CITY OF HOBART

City Planning Committee Meeting

**13. 646A SANDY BAY ROAD, SANDY BAY - PARTIAL DEMOLITION,
ALTERATIONS, AND PARTIAL CHANGE OF USE TO FOOD SERVICES
PLN-21-368 - FILE REF: F21/69383**

Proposal: Partial Demolition, Alterations and Partial Change of Use to Food Services

PROPOSED PLAN
1:100

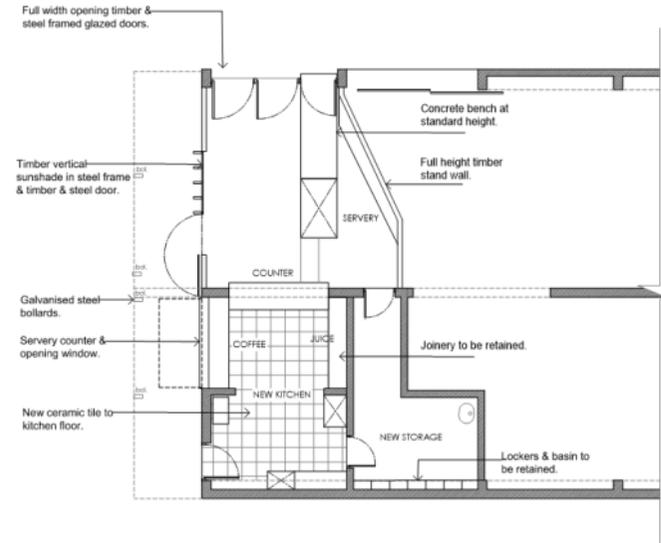
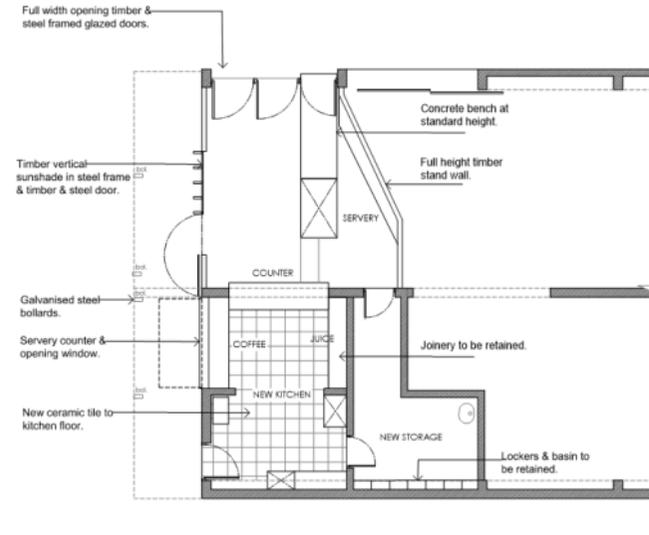
The proposed changes to the north/east (entry) and the north/west (coffee servery) as shown on drawings Floor Plan 21.04_DA02, dated 29/04/21 and Elevations 21.04_DA03, dated 29/04/21 are not approved. Revised drawings must be submitted to include the following:

-The proposed full height timber stand wall (drawing 21.04_DA02) to be built to separate the café from the rescue craft / kayak storage sections of the pavilion is inadequate from a noise attenuation perspective. This wall will need to be more substantial e.g. a concrete block masonry wall;

3. The proposed full height timber stand wall (drawing 21.04_DA02) to be built to separate the café from the rescue craft / kayak storage sections of the pavilion is inadequate from a noise attenuation perspective. This wall will need to be more substantial e.g. a concrete block masonry wall.

The drawing submitted on 12 July 2021 and described as: Elevations - Revised, 21.04_DA03, dated 09/07/21, reflects an outcome that would satisfy this condition.

NORTH-EAST ELEVATION
1:100

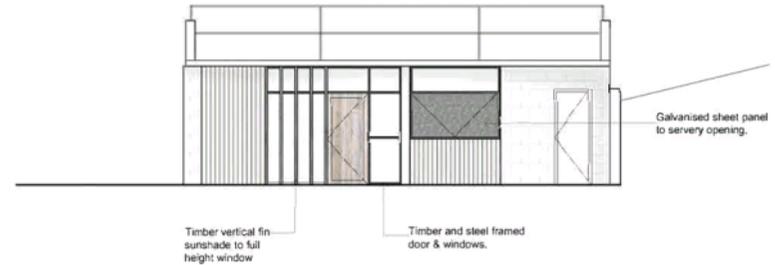
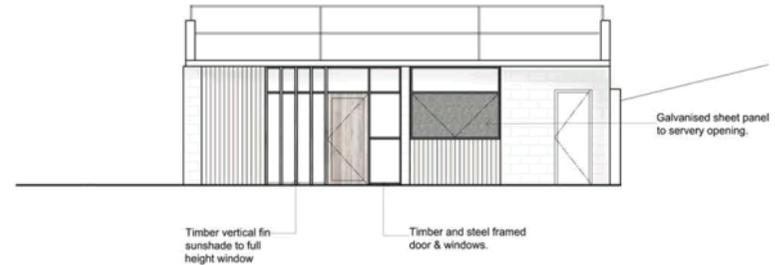
Also, it is not clear from the submitted plans where 'the bollards proposed beyond the building envelope' will be located or what their purpose will be. The steel RHS bollard in drawing 21.04_DA03 appears to be an existing bollard.

The revised drawings show that the division of the north/east elevation facing the water (portion only) into threes, reflects the existing building. The architecture is respected and understood.
